ER0023
Errata
SmartFusion Devices

This errata sheet contains updated information about any known SmartFusion[®] device family specific issues and provides available fixes and solutions.

Figure 1 • SSE Micro Architecture

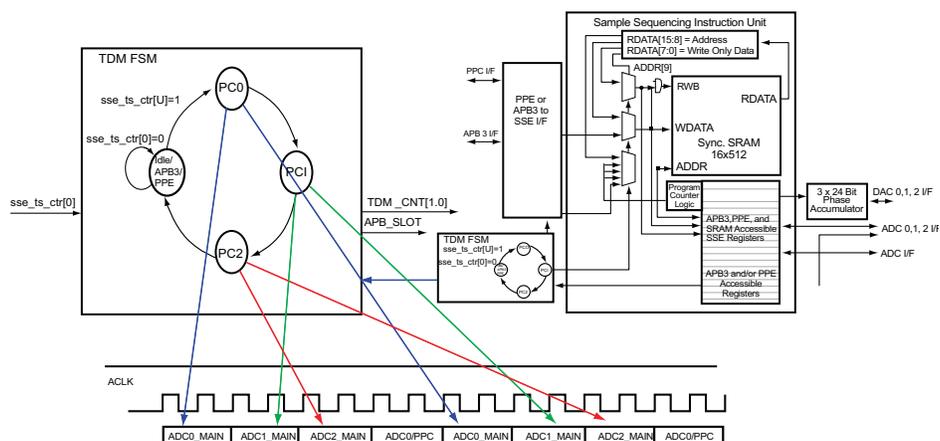
3.8 Channels that need strobing, such as CM4 and TM4, show up under ADC0 or ADC1 (ACE Controller tab in software) instead of ADC2

The TM4 and CM4 are pads that connect directly to the ADC2 (available only on the A2F500 device). Part of the ACE controller is a Time Division Multiplexing (TDM) FSM, which implements a mechanism to sequence through the different ADCs available on the SmartFusion devices. The FSM allows equal access through three separate program counters. program counter0 (PC0) is associated with ADC0. program counter1 (PC1) is associated with ADC1 and program counter2 (PC2) is associated with ADC2, as shown in the following figure.

The strobe channels on ADC2 (current, temperature, differential voltage) are instead made available through the ADC Controller tab in software on the procedures that are targeted for ADC0 or ADC1 (instead of ADC2 where they are supposed to be available). This is a software workaround. Even though the ADC2 analog signal moved under the PC0 and/or PC1 time slot, physically those analog signals are still connected to ADC2 and are sampled on the ADC2. You should be aware that there will be a contention when sampling is performed on one ADC and then simultaneous samples are performed on the other procedure using the same ADC. The likely outcome of such a scenario is that the samples are dropped. Furthermore, the ACE controller issues a warning, as shown in the following figure.

Figure 2 • Sampling Simultaneous Operations

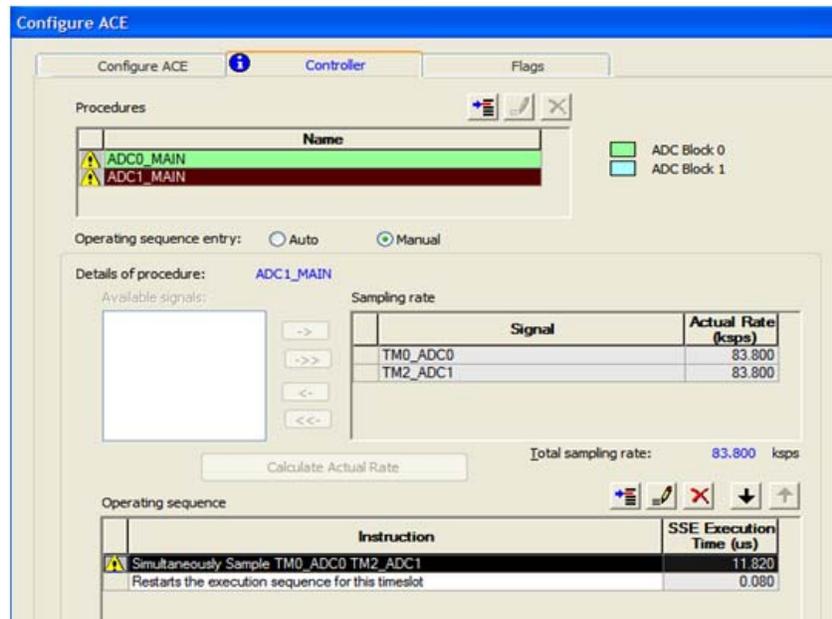
In such a situation there is contention of the ADC resources. This leads to the ADC sampling data being dropped occasionally, as indicated by the warning message shown in the following figure. To fix this issue, you can either change the procedure specification, so you don't use the same ADC in the multiple

Note: Sampling of TM0_ADC0 conflicts with simultaneous operation of procedure(s) for ADC0. See, the ACE Configuration user guide for more information.

procedures or the firmware must enable/disable the procedures so that the conflicting procedures are not simultaneously active at the same time.

The ACE driver Use Guide has an API that you can use to enable/disable the procedures.

Figure 4 • Reset Management Configurator

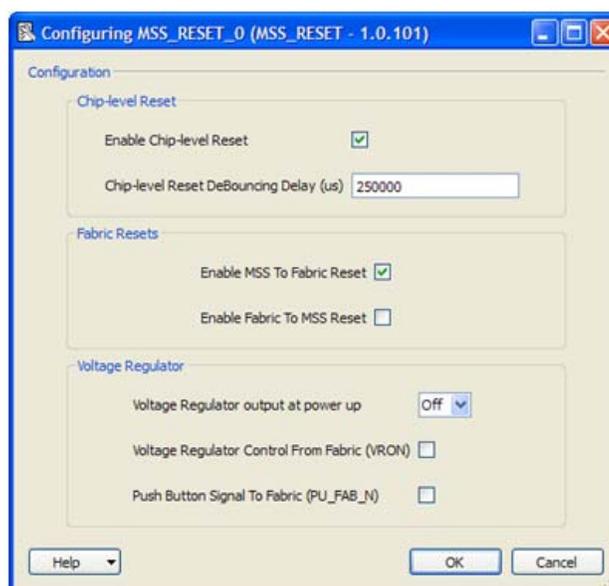
This issue happens if the debouncing delay generated by the external reset chip does not match the chip level reset debouncing delay specified in the Reset Management configurator in the MSS, as shown in the following figure.

Ensure that the chip level reset debouncing delay specified in the Reset Management configurator in the MSS matches the external reset chip delay.

Figure 5 • System Behavior Option after System Configuration

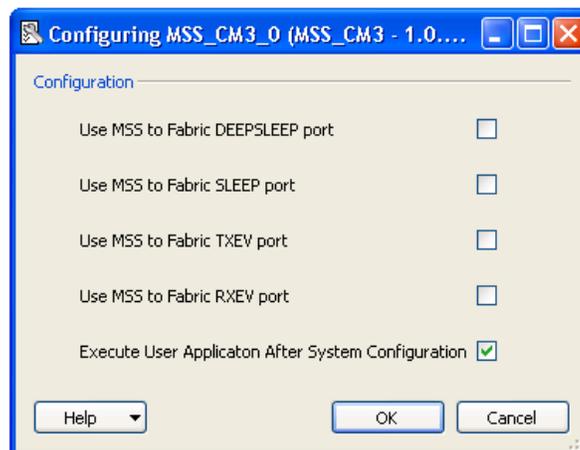
When there is no application design, the device periodically resets after system configuration, even though the Watchdog was disabled. The system boot should not go to the application if there is no application specified.

A new option, **Execute User Application After System Configuration**, has been added into the Cortex-M3 configurator as per the following figure, that gives the user the flexibility of deciding the behavior after the system configuration. The option is ON by default, which indicates that your application is executed after system configuration. If you do not have any application to run, the check box options should be cleared.

Figure 7 • ACE Data Path Available Tapping Points

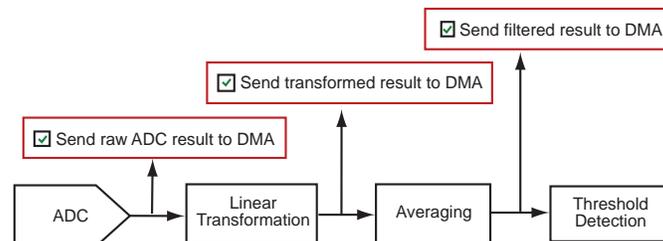
In Libero SoC v10 SP1, the PPE microcode is incorrectly generated when **Send filtered value to DMA** is enabled. Prior to Libero SoC v10 SP1 the microcode was generated correctly.

Update to Libero SoC software v10 SP2 or later.

Figure 8 • Glitchless Multiplexer

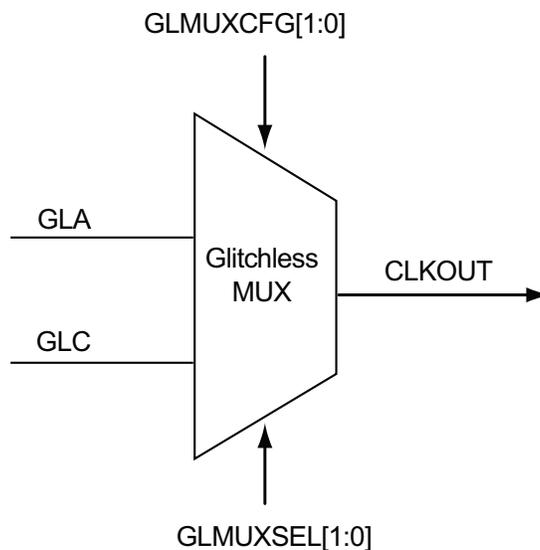
3.23 Signal driving fabric CCC/PLL glitchless mux (NGMUX) must be a free running clock signal

The signal assigned to the GCAx pins (Example: GCA0/IO36NDB1V0, GCA1/IO36PDB1V0, and others) as a CLKBUF or CLKBUF_LVPECL or CLKBUF_LVDS goes through the glitchless mux. For the glitchless mux to operate correctly, the signal must be a free-running clock signal. See the “**Glitchless MUX**” section in the *SmartFusion Microcontroller Subsystem User Guide* for more information. Verify that the signal driving this instance is a continuous clock signal.
